**re: Preliminary Geotechnical Review - Proposed SWMP**  
**Proposed Residential Development**  
**Cardinal Creek Village South – Ottawa, Ontario**

**to:** Taggart Investments - **Ms. Michelle Taggart** - [mtaggart@taggart.ca](mailto:mtaggart@taggart.ca)  
**to:** HP Urban Inc. - **Mr. Peter Hume** - [peter.hume@hpurban.ca](mailto:peter.hume@hpurban.ca)  
**to:** DSEL - **Mr. Braden Kaminski** - [Bkaminski@dsel.ca](mailto:Bkaminski@dsel.ca)  
**date:** December 2, 2022  
**file:** PG5201-MEMO.01 Revision 2

**POND OUTLET SECTION**  
N.T.S.

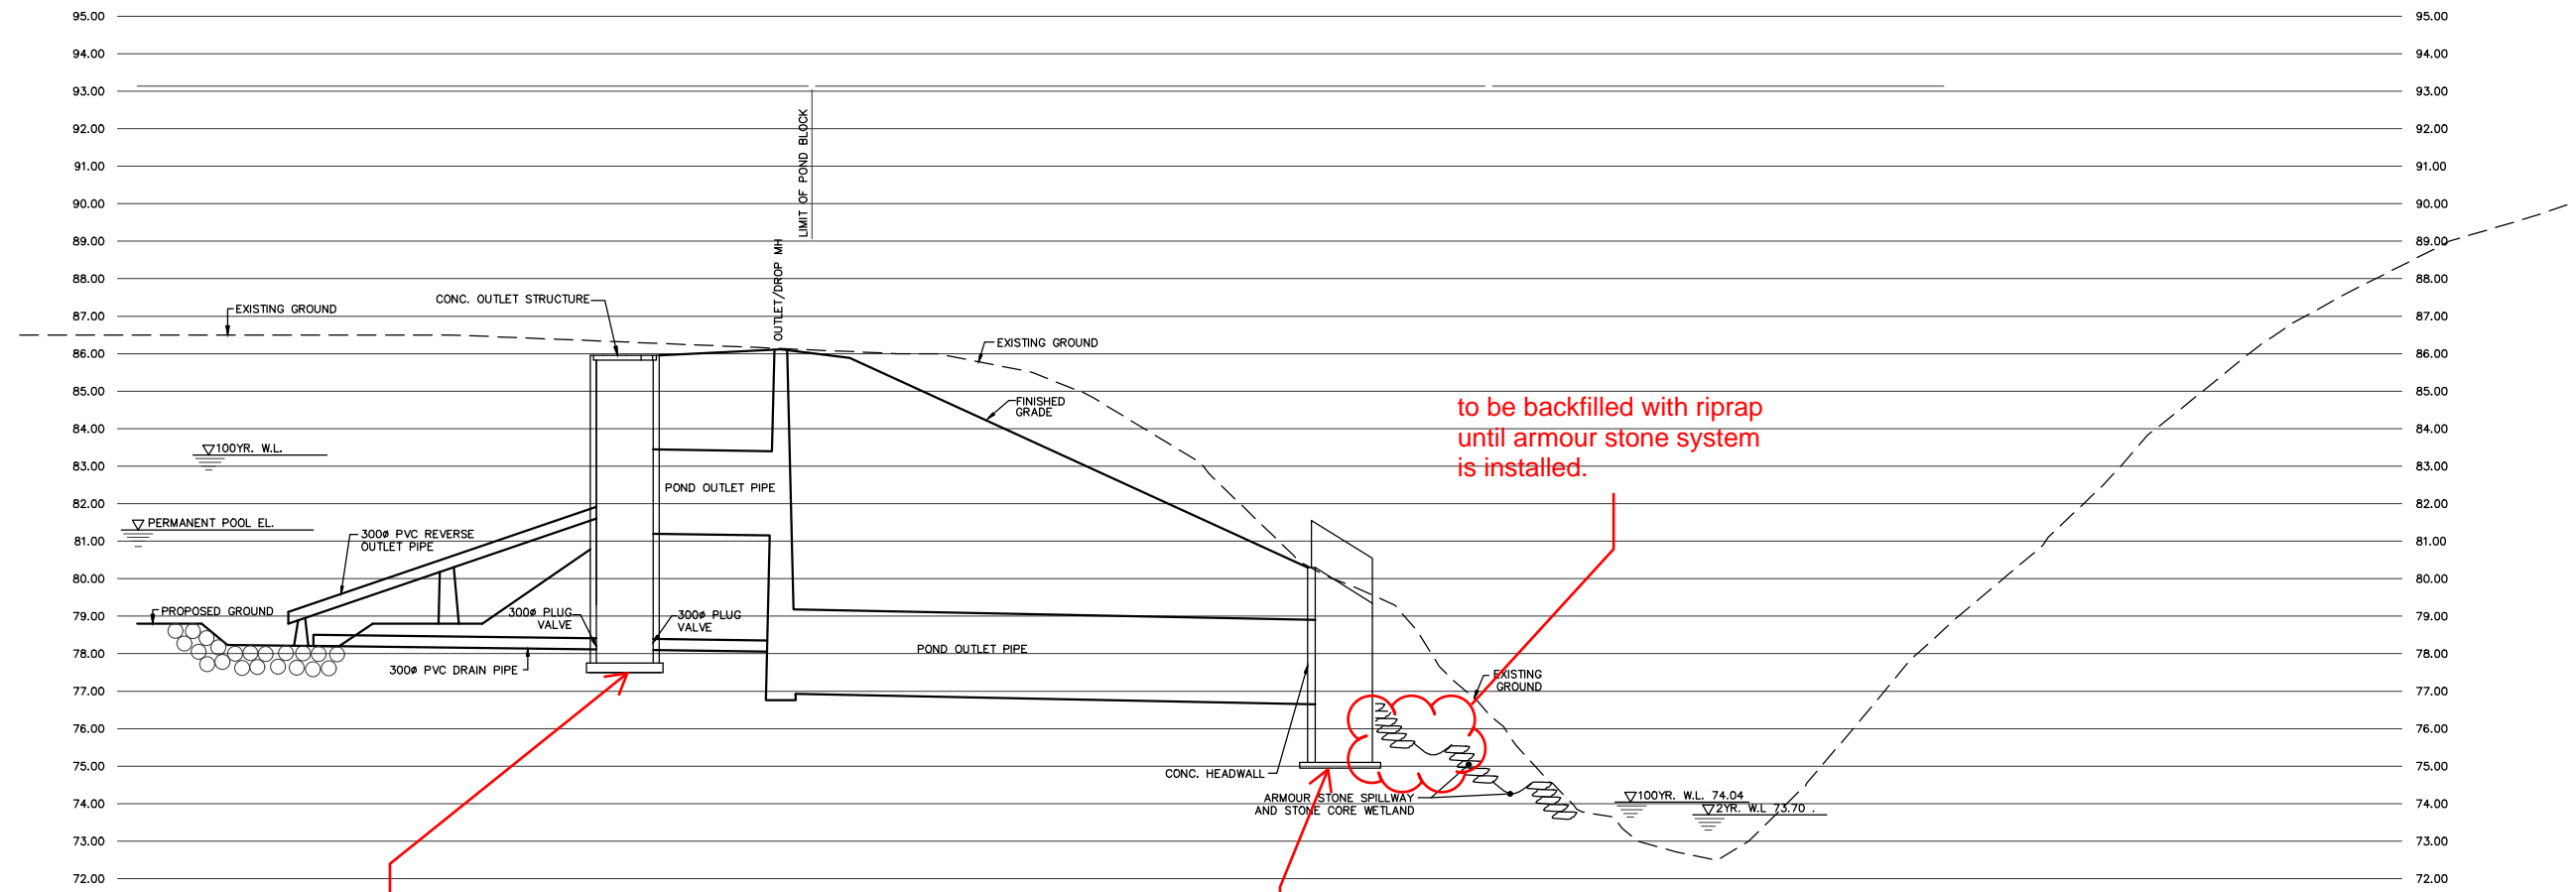
Paterson reviewed the current preliminary design drawings for the SWMP outlet structure (attached to the end of this memo). Based on our review, the proposed concrete headwall and outlet structures will be founded on Stiff grey silty clay and/or inferred glacial till. The bearing resistance values for the proposed structures can be taken from the "bearing capacity for concrete structures" section in the previous page.

If the bottom concrete headwall is founded over silty clay or glacial till, it is highly recommended that riprap stone be placed against the bottom of the headwall structure to prevent the running water from undermining the headwall footings until the armour stone wall system is constructed. The riprap stone should consist of stone fragmented to maximum size of 400 mm with sharp edges to allow for interlocking between the riprap material.

Paterson Notes: Bearing medium expected to be Stiff Grey Silty Clay and/or Glacial till.

Paterson Notes: Bearing medium expected to be glacial till over bedrock and/or bedrock.

to be backfilled with riprap until armour stone system is installed.
